100G SR4 TxVEC - TDP Update (D2.1 comment 94)

John Petrilla: Avago Technologies
March 2014

Review: 100G 100 m SR4: Transition time & RIN₁₂OMA tradeoff set TP2 contours

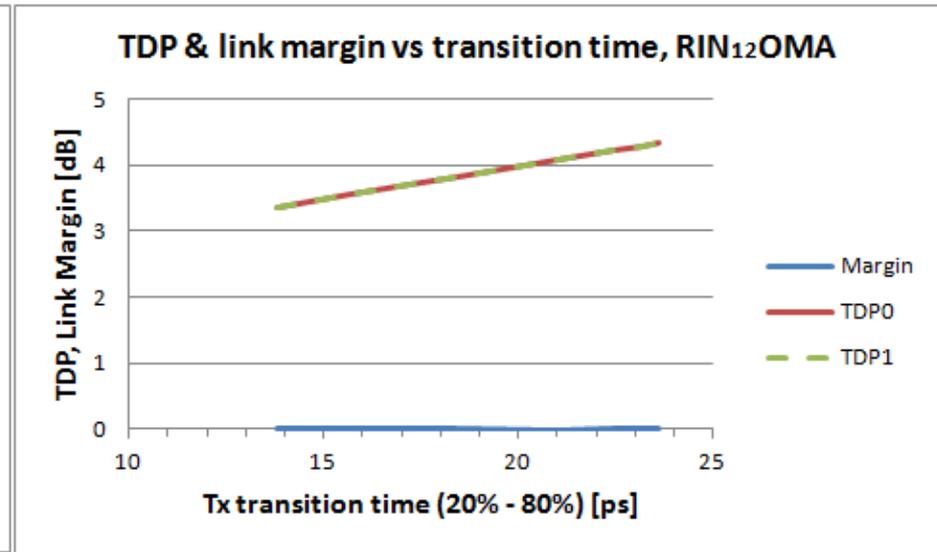
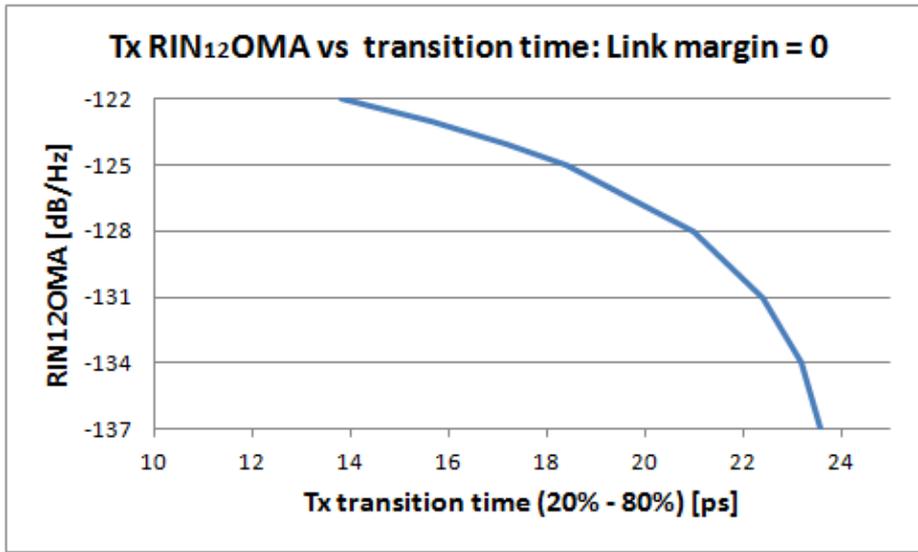
• For a system with three variables, transition time, RIN₁₂ OMA & jitter, and one result, link margin, there is no unique worst case, rather a multiplicity of worst cases. Each of these cases yields a slightly different eye contour as can be seen in the figures on the left as well as a different TDP value that will be discussed later.

• The top chart shows 5E-5 contours of the Tx output (TP2) for transition time and RIN₁₂OMA combinations providing zero link margin. Here a Gaussian response is assumed, consistent with the assumptions in the link model.

• Items to notice in this set of contours:

- 1, All of the Tx and TP1 attributes that are intended to be captured in the TDP metric are captured in these contours.
- 2, The vertical position of a point on a contour represents the signal amplitude at that point relative to OMA and permits a measure of vertical eye closure.
- 3, There's a crossover point where the variations in time and amplitude are minimized that offers a tighter relationship with link margin than TDP offers (more on this later).

The currently defined (draft 2.1) Tx eye mask is included in the bottom chart with a more comprehensive set of worst case cases.

Review: 100G 100 m SR4: Attribute tradeoffs using TDP & Link Margin

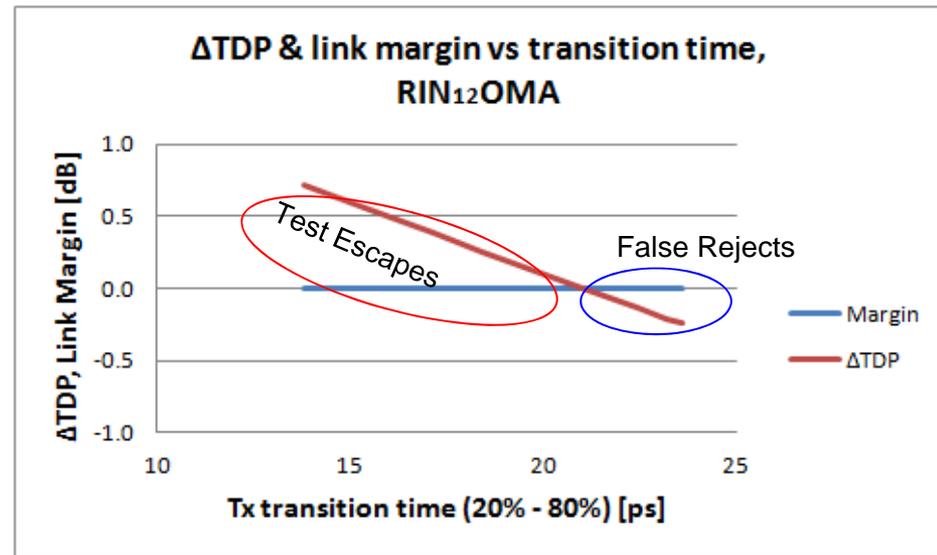
•The top left chart shows the tradeoff between Tx transition time and RIN₁₂OMA using the Example Link Model when holding link margin constant at 0 dB. The values in the Example Link Model are transition time = 21 ps and RIN₁₂OMA = -128 dB/Hz.

•The top right chart shows TDP values calculated for the combinations of transition times and RIN₁₂OMA. Here TDP0 is for a 100 m reach case and TDP1 is for the test filter case. While the link margin is constant the TDP results are not, i.e. TDP does not tradeoff transition time and RIN as the link model does.

•The bottom right chart shows the deviation in link margin and TDP from the initial combination of transition time = 21 ps and RIN₁₂OMA = -128 dB/Hz. Positive Δ TDP values may lead to test escapes and negative values may lead to rejecting acceptable units.

New: 100G 100 m SR4: Zero Margin Cases

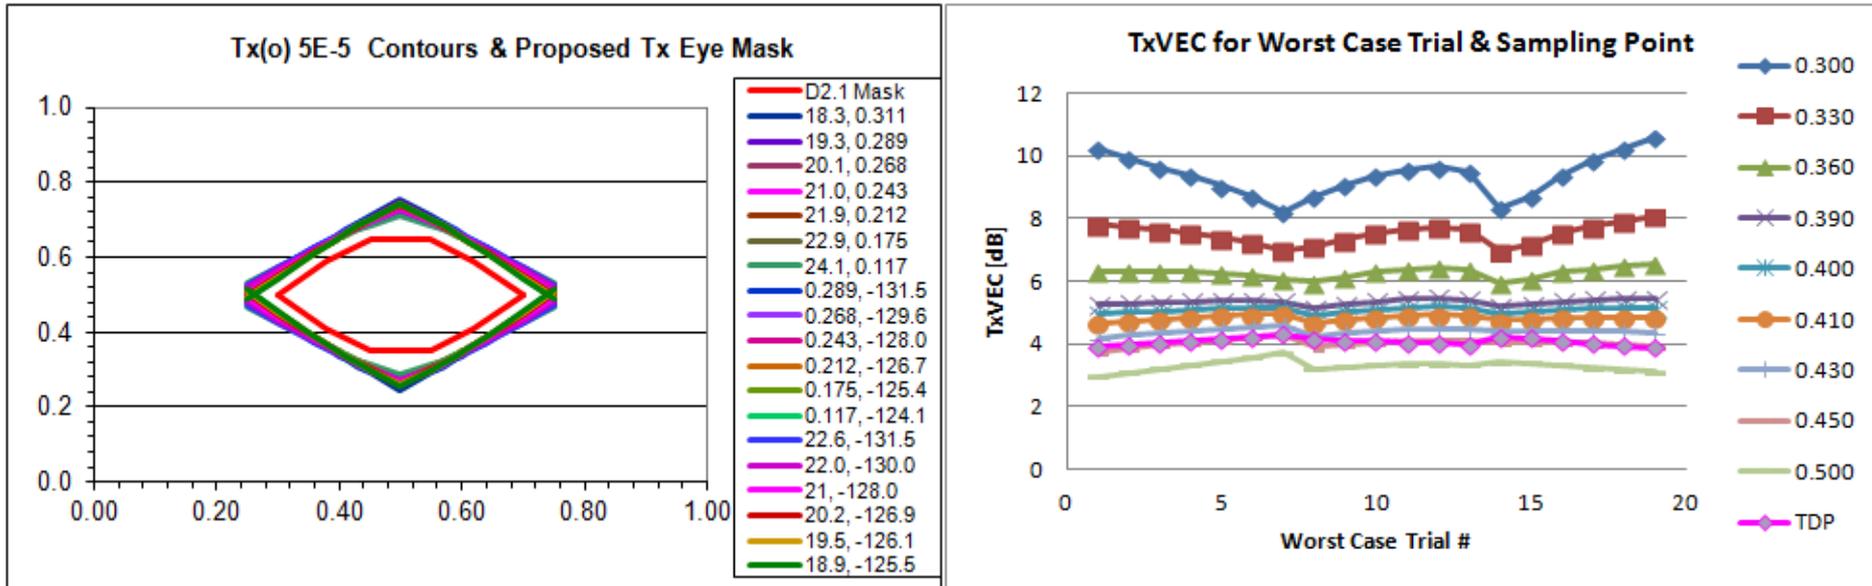
- The above left chart show Tx output contours for a family of worst case transmitters as well as the Tx eye mask defined in draft 2.1.
- The above right chart shows, for this worst case family, TDP and VEC calculated for various sampling points in the unit interval where 0.50 is the center of the eye.

- Variability in the TxVEC and TDP results can be seen among the family of worst case transmitters.
- Variability in the TxVEC result is minimized in the region of 0.39 UI to 0.41 UI.

- For 0.39 UI, Max TxVEC – Min TxVEC = 0.34 dB, Average = 5.33 dB
 - For 0.40 UI, Max TxVEC – Min TxVEC = 0.31 dB, Average = 5.07 dB
 - For 0.41 UI, Max TxVEC – Min TxVEC = 0.29 dB, Average = 4.83 dB

- For TDP, Max – Min = 0.43 dB
- The minimum variability TxVEC region appears sufficiently wide to permit reasonable accuracy in placing the histograms for the TxVEC measurement and/or reasonable width in the histogram to enable acceptable sample collection times.

- From the above it's recommended that TxVEC max = 5.0 dB is applied to histograms placed at 0.40 UI and 0.60 UI.

New: 100G 100 m SR4: Tx Attribute Margin Sensitivities (1)

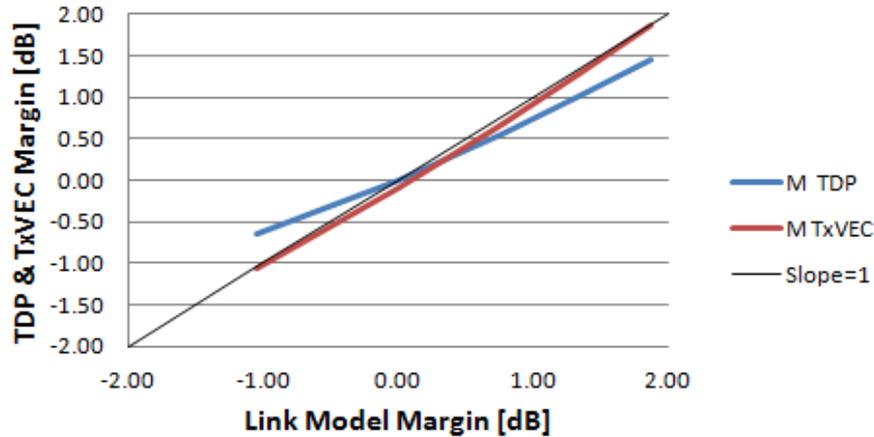
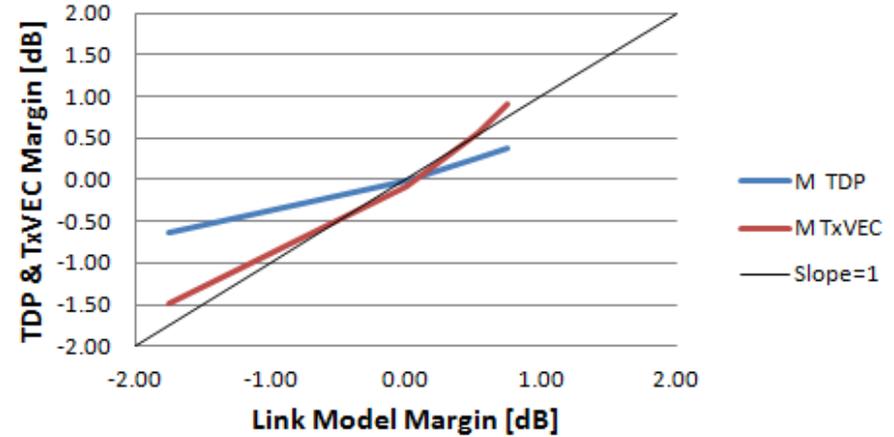
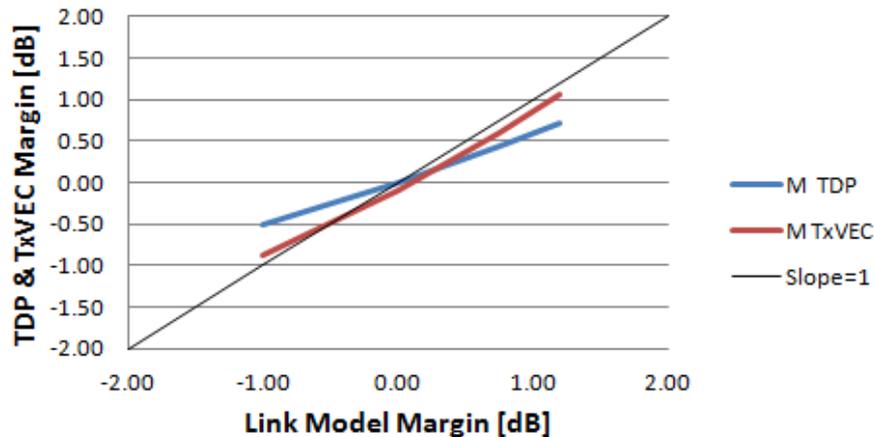
- Here Tx attributes are re-examined, this time for effect on TxVEC as well as on link model and TDP margin.
- For each Tx attribute, TxVEC is more closely aligned with link margin than TDP.
- TxVEC margin is based on Tx VEC max = 5.0 dB measured at ± 0.10 UI from the center of the eye, i.e. 0.50 UI.

New: 100G 100 m SR4: Tx Mask Margin in lieu of TDP

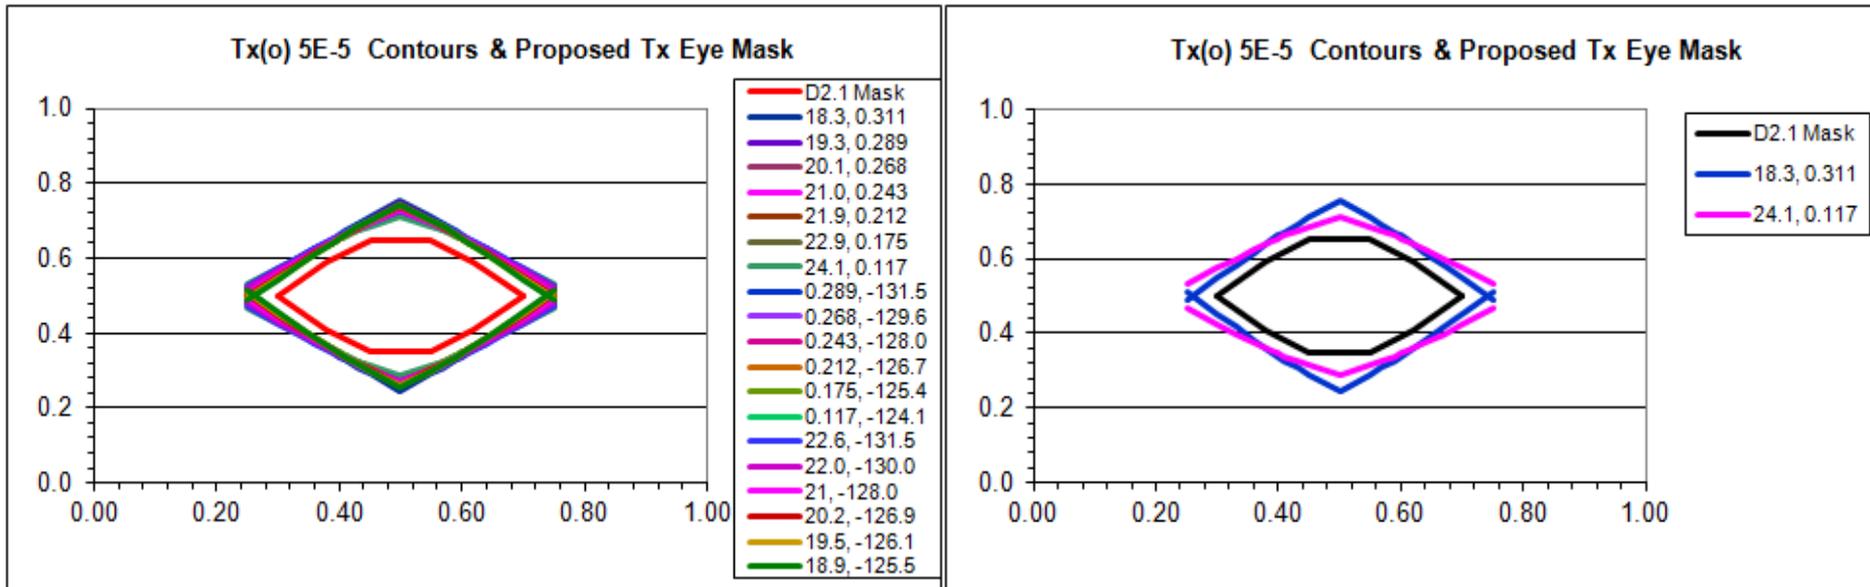
- Due to the difficulties of TDP measurements, some have looked to Tx mask margin as a predictor of link margin.
- Problems associated with use of Tx mask margin start with the lack of a common definition, i.e., different test equipment vendors use different mask margin algorithms yielding different results for a Tx under test.

- Further, while the chart on the left with the overlay of 19 zero-link-margin device contours may lead to the conclusion that there could be common mask margin result for all these cases with the same link margin, the chart on the right with just two of the cases shows the likelihood of different mask margin results from devices with the same link margin.

- Defining a TxVEC test may reduce the incentive to use non-standardized tests and reduce the confusion and/or frustration that occurs when correlation is sought between mask margin test results for cases where a vendor is using a set of test equipment with one mask margin algorithm and the customer is using a different set of test equipment with a different mask margin algorithm.

Review: 100G 100 m SR4: A metric to replace TDP (2 of 6)

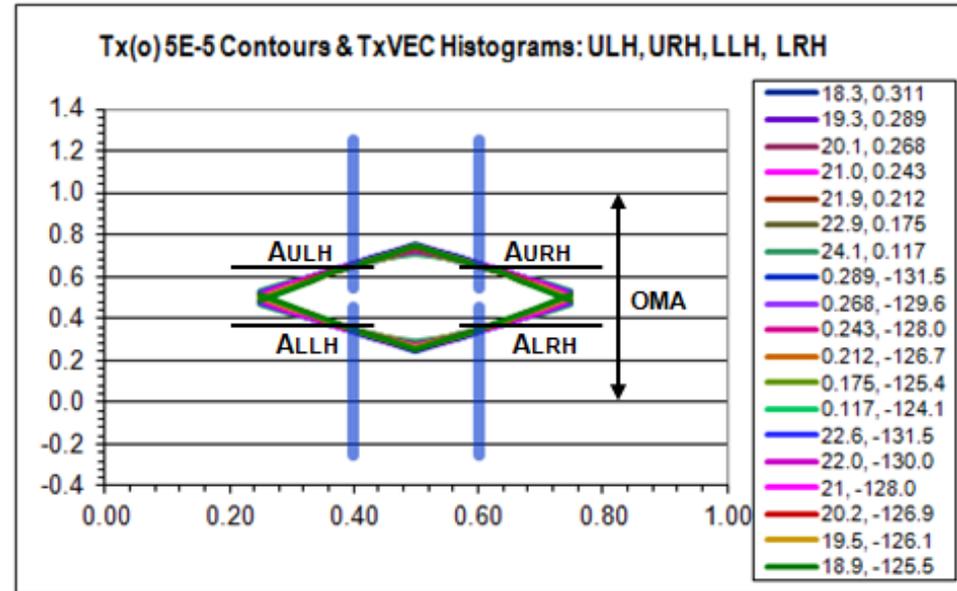
Proposed replacement text for 95.8.5

95.8.5 Transmitter Vertical Eye Closure

Transmitter Vertical Eye Closure (TxVEC) shall be as follows:

- Each optical lane is tested individually with all other lanes in operation.
- The transmitter is tested using an optical channel with an optical return loss of 12 dB.
- OMA shall be measured as defined in 95.8.4.
- The transmit eye is observed as defined in 95.8.7 with the following exception: eye mask coordinates are not applied.
- The transmitter optical waveform is measured for vertical eye closure (TxVEC) with vertical histograms at ± 0.1 UI from the eye center. TxVEC is the larger of the four quantities

$TxVEC(ULH) = -10\log_{10}(2 \times A_{ULH} - 1)$ where A_{ULH} is the signal amplitude at the 0.005th percentile level of the Upper Left Histogram

$TxVEC(URH) = -10\log_{10}(2 \times A_{URH} - 1)$ where A_{URH} is the signal amplitude at the 0.005th percentile level of the Upper Right Histogram

$TxVEC(LLH) = -10\log_{10}(1 - 2 \times ALLH)$ where $ALLH$ is the signal amplitude at the 0.005th percentile level of the Lower Left Histogram

$TxVEC(LRH) = -10\log_{10}(1 - 2 \times ALRH)$ where $ALRH$ is the signal amplitude at the 0.005th percentile level of the Lower Right Histogram
